Product/Process Change Notice (PCN)

PCN Number: PCN_ConPSHD_20250715

Affected Series: WR-PSHD

DETAILS OF CHANGE: DIMENSIONS DRAWING

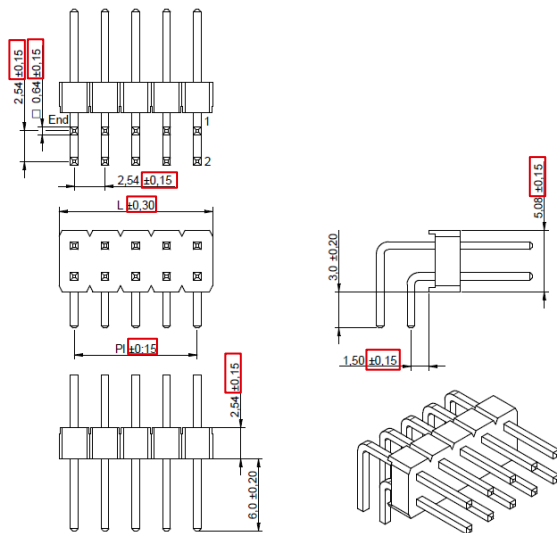
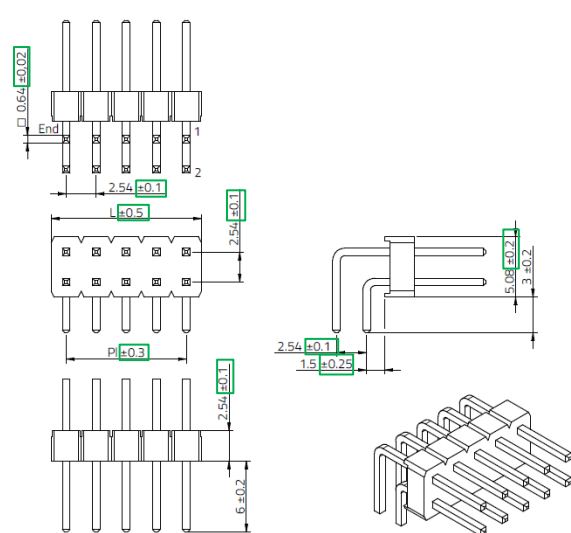
Because of a database mismatch, Würth Elektronik eiSos will correct the tolerancing on the product & recommended hole pattern drawings.
